**Freightliner  
 Service Bulletin**

## General Information

**Fig. 2, Alternate Transmission Interface Connector**

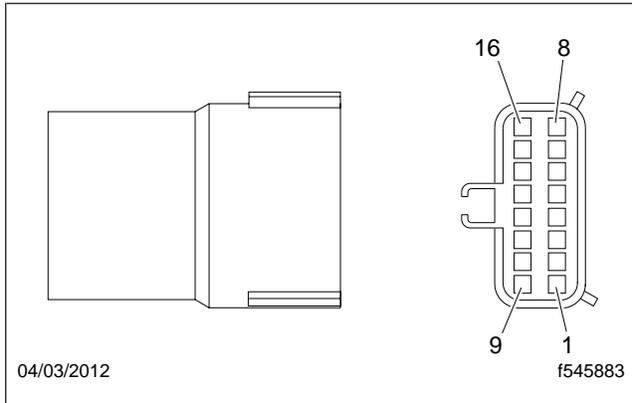
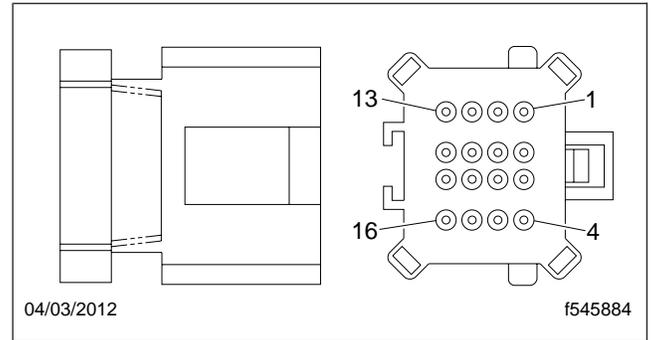
Vehicles built between June 1, 2011, and October 1, 2011, may have an alternate transmission interface connector installed due to a shortage from the supplier. See [Fig. 1](#) and [Fig. 2](#).

The alternate connector is mapped 1-to-1 with the standard connector, and the wiring remains the same. Refer to [Table 1](#) for connector and terminal details.
